**SOUTH DAKOTA
WATER PERMIT NO. 5860-3**

DOHN DAM
SD-169-001

REPORT ON
WATER PERMIT APPLICATION NO. 5860-3
Theophil Dohn
May 16, 1995

**RECOMMENDATION OF CHIEF ENGINEER FOR WATER PERMIT
APPLICATION NO. 5860-3, Theophil Dohn**

Discharge Curve

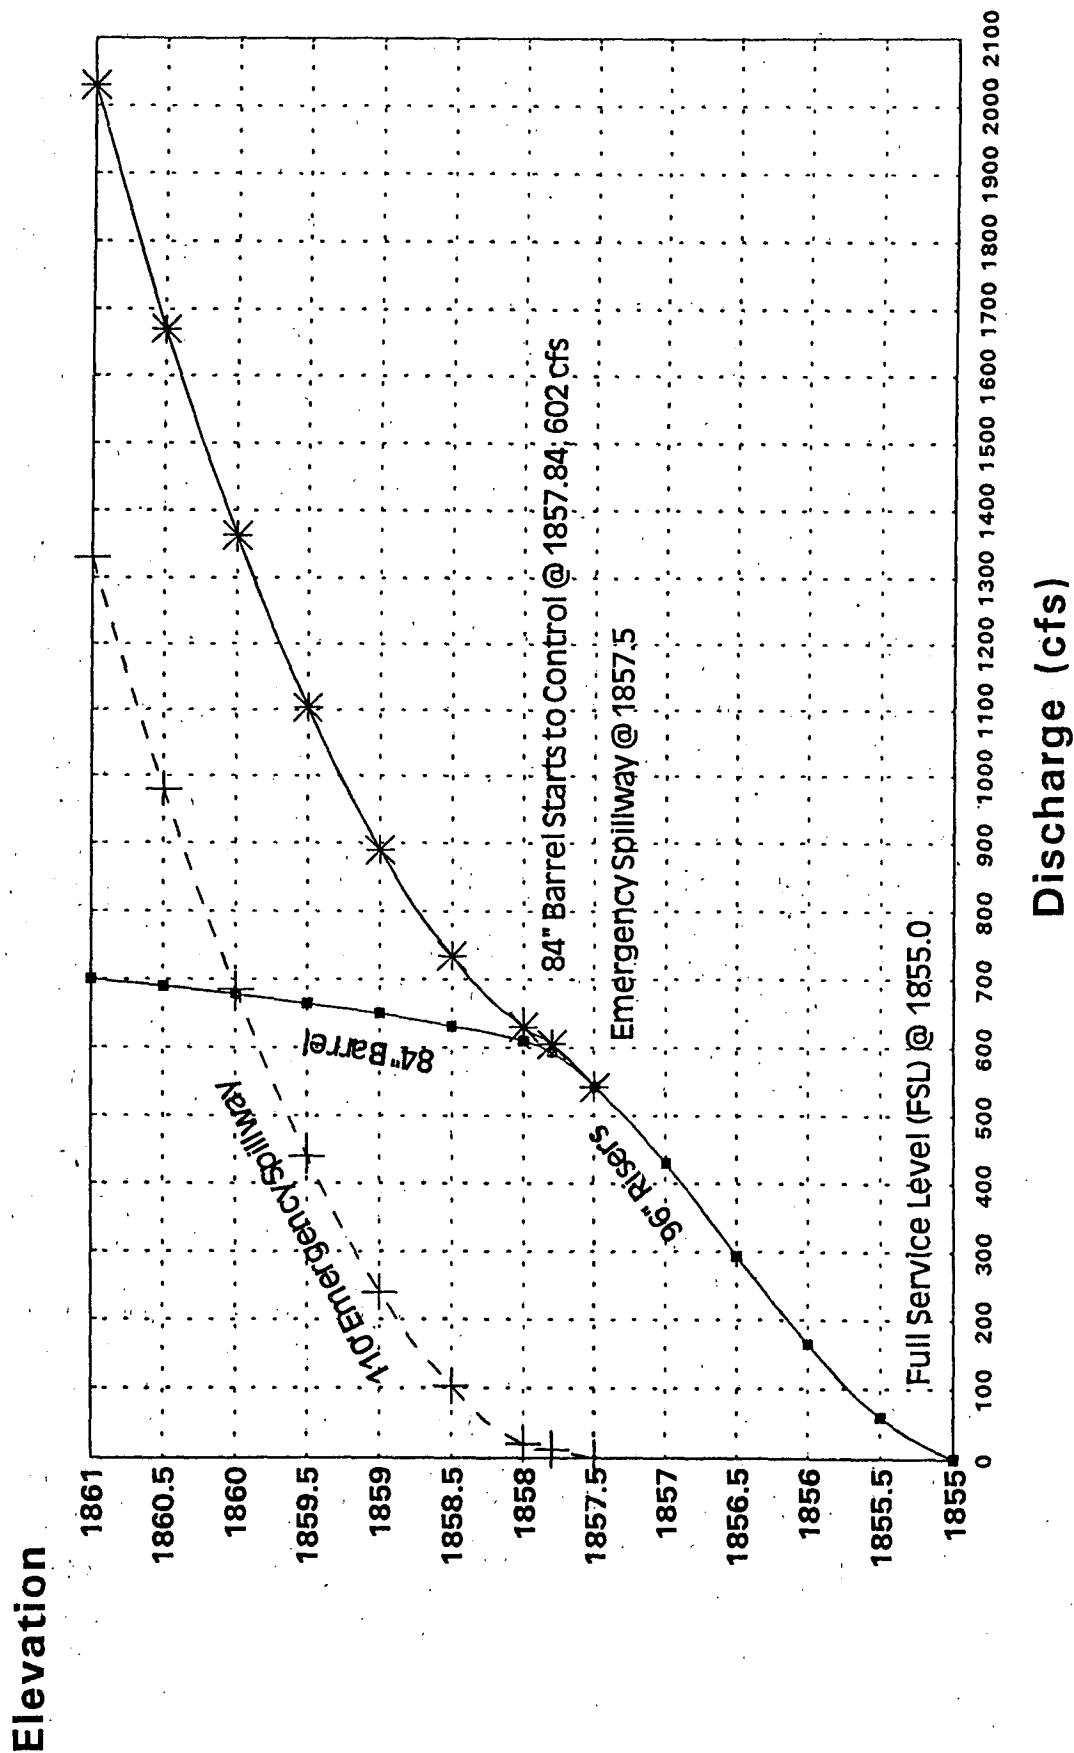
Top of Dam Elev. - 1861
Primary Spillway Elev. - 1855 - 35.58 Ac-Ft.
2nd Spillway Elev. - 1857.5 - 152.70 Ac-Ft.
Height - 17 feet

Cat. 3 - Low Hazard

Intermediate Storage (73.6 Ac-Ft) times Effective Height (11.5 ft.)
equals 847 $\therefore$ 25 year frequency Minimum Spillway Design

Spillway Q check

2-96" Risers w/ 84" Barrel & 110 ft. Emergency

Weir flow until Elev. 1857.84 then Orifice flow thru 84" Barrel

$$\begin{aligned} Q &= C L H^{3/2} \quad L = 2-96" \text{ Riser Circ} = 25' \times 2 = 50 \text{ ft} \\ &= 3(50)(2.84)^{1.5} \quad H = 2.84 \\ &= \underline{700 \text{ cfs}} \quad \text{OK} \quad \text{DU used smaller C value} \end{aligned}$$

$$\begin{aligned} Q &= C A \sqrt{2gh} \quad C = 0.60 \quad H = 15 \text{ ft} \quad A = 38.46 \text{ ft}^2 \\ &= (0.60)(38.46) \sqrt{2(32.2)(15)} \\ &= \underline{717 \text{ cfs}} \quad \text{OK} \end{aligned}$$

2nd Spillway - Weir Elev. $C = 2.6 \quad L = 110 \quad H = 3.5$

$$\begin{aligned} Q &= C L H^{3/2} \\ &= (2.6)(110)(3.5)^{1.5} \\ &= \underline{1872 \text{ cfs}} \end{aligned} \quad \text{DU used smaller C w/ Approx } \underline{1300 \text{ cfs}}$$

$$\begin{aligned} \text{Total } Q &= 1872 \\ &+ 717 \\ &\underline{2589 \text{ cfs}} \end{aligned}$$

Ducks Unlimited uses TR-20 to route a Q₂₅ Peak of 1019 cfs thru the dam with Max. Elev. = 1859.26, leaving 1.74 feet of freeboard; and Q₁₀₀ Peak of 1934 cfs thru the dam with Max. Elev. = 1860.85, leaving 0.15 feet of freeboard. Their procedure uses small peak flow values, but also used smaller C values for spillway flows.
